## RESPONSE LETTER NO. 2 TO REQUEST FOR INFORMATION

**Project Title:** Snowden Pedestrian Bridge No. 879043

**Project No.:** 20240235

Picture:

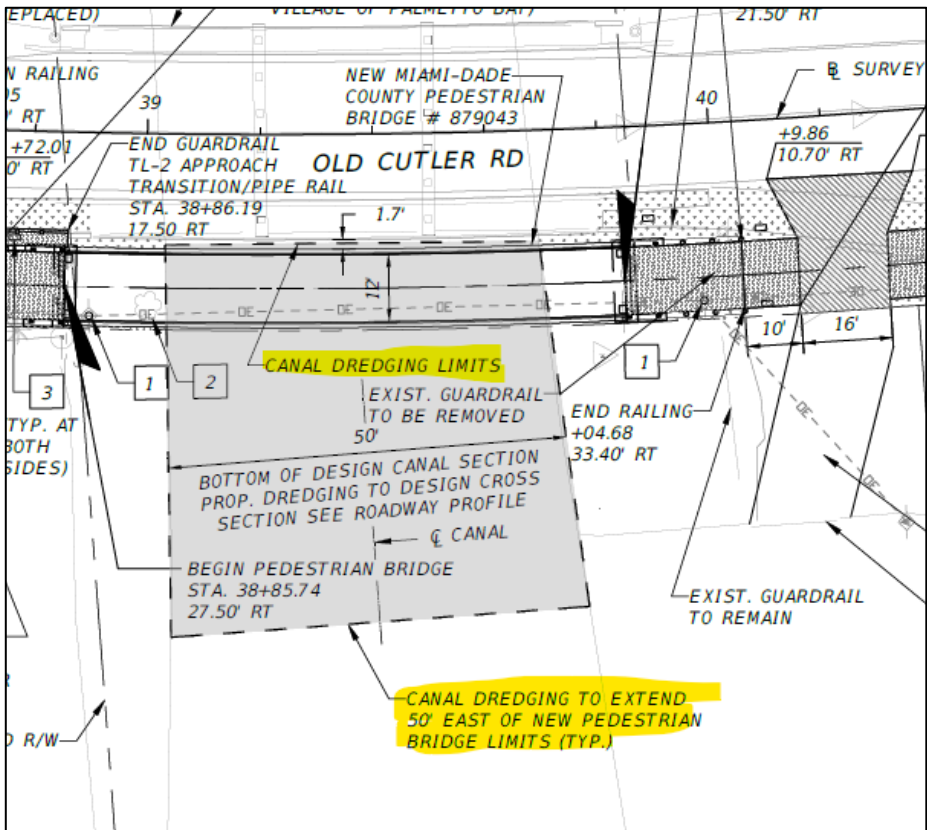
**Question No. 2:** On the right-hand side of the guardrail line it states to end guardrail with an approach transition. Could you clarify if a new wall will be constructed or will we be connecting to the existing wall (shown below).

**Answer No. 2:** The new guardrail will need to be connected to the existing rigid barrier.
